Access Compliance Report Public Rights-of-Way (Curb Ramps)

Main Street: VILLA_PARK_RD Cross Street: SANTIAGO_BLVD Location: NW

ADA ID: RPRK211222122126 Ramp Type: Blended Transition 2 Initial Pass/Fail: Fail Overall Compliance: No Severity Score: 16

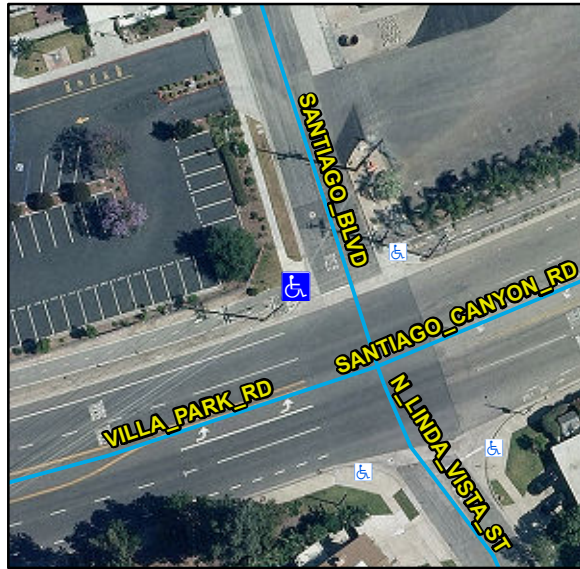
Compliance	Description	Data	Compliance	Description	Data
N/A	Ramp Length (in)	55	N/A	Flare Slope LT (%)	N/A
Yes	Ramp Width (in)	160	N/A	Flare Traversable LT	N/A
No	Ramp Run Slope (%)	10.3	N/A	Flare Slope RT (%)	N/A
No	Ramp Cross Slope (%)	2.5	N/A	Flare Traversable RT	N/A
N/A	Landing Present	N/A	N/A	DWS Provided	N/A
N/A	Landing Length (in)	N/A	N/A	DWS Contrast	N/A
N/A	Landing Width (in)	N/A	N/A	DWS Length (in)	N/A
N/A	Landing Run Slope (%)	N/A	N/A	DWS Full Width	N/A
N/A	Landing Cross Slope (%)	N/A		DWS Offset Type	N/A
N/A	Landing Movement Obstructed?	N/A	N/A	DWS Offset Left (in)	N/A
	Landing Movement Type	N/A	N/A	DWS Offset Right (in)	N/A
N/A	Landing Shared	N/A			
N/A	Clear Space	Yes			
N/A	Clear Space To Crosswalk (in)	N/A			
N/A	Marked Crosswalk 1	No	N/A	Marked Crosswalk 2	No
	Crossing 1 Direction	S		Crossing 2 Direction	E
	Marked Crosswalk 1 Width (in)	N/A		Marked Crosswalk 2 Width (in)	N/A
N/A	Ramp Inside Crosswalk 1	N/A	N/A	Ramp Inside Crosswalk 2	N/A

Remove & Replace Curb Ramp With Two New Directional Ramps or Equivalent.
